Memorandum

Subject: DP 4860 Kibby Expansion, Response to MDIFW Comments, as Transmitted via E-mail March 4, 2010

Date: April 8, 2010

TransCanada
 Kibby Expansion
 15 WTG Layout
 April 1, 2010

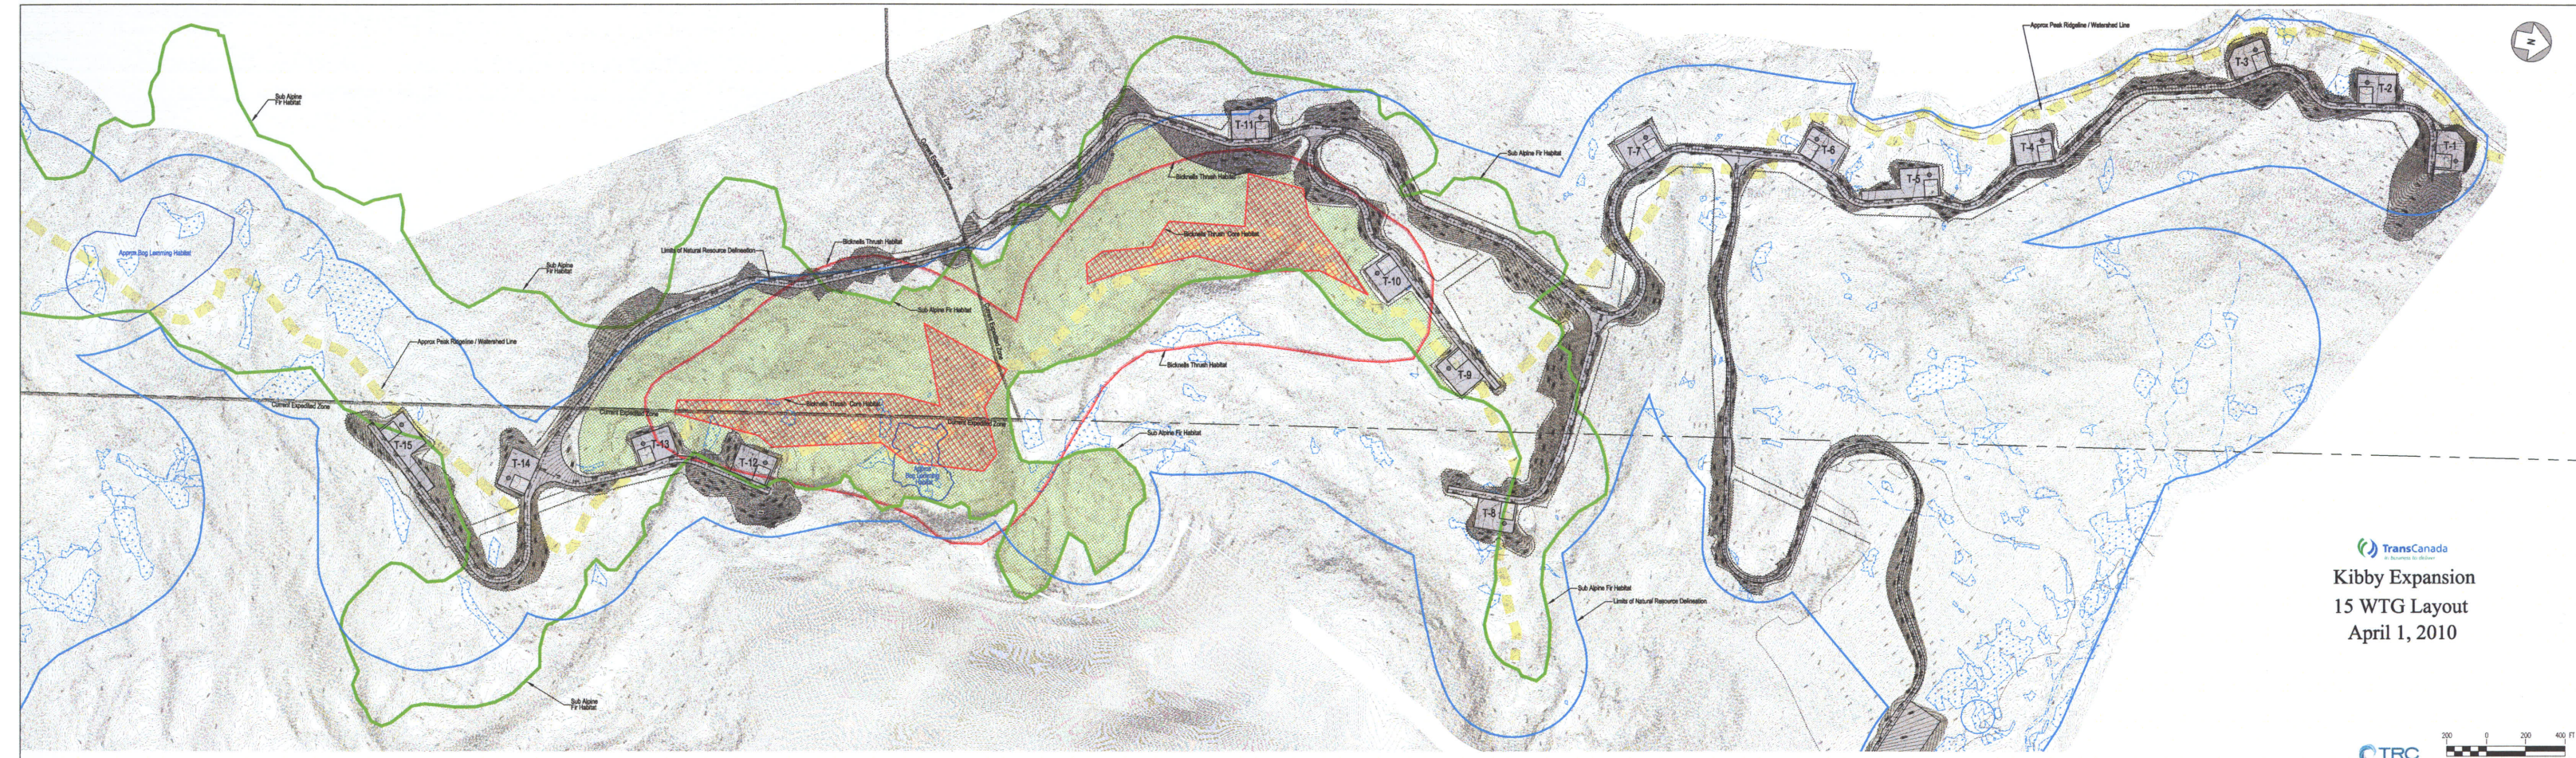
MDIFW Comment - Bicknell's Thrush: As currently proposed, this project has 5 turbines that will occur within Bicknell's Thrush habitat. Of those 5 turbines, Turbine # 11 and its access road are of greatest concern to MDIFW, because this development will essentially bi-sect the habitat block. Therefore, we recommend the following options (in order of preference) 1) the applicant relocated Turbine # 11 and its access road, or 2) The applicant implement a set of operational restrictions for Turbine # 11, during nesting and brood rearing periods for this species. The specific details of these restrictions should be developed between LURC, MDIFW and the Applicant. Also under option #2, a post-construction monitoring protocol needs to be implemented for this species with at least the same rigor and scope as the pre-construction studies.

TransCanada Response: Turbine #11 and the associated access road has been relocated downslope and west, moving it to the edge of suitable Bicknell's thrush habitat, consistent with the MDIFW first preference. See the attached map for the revised layout.
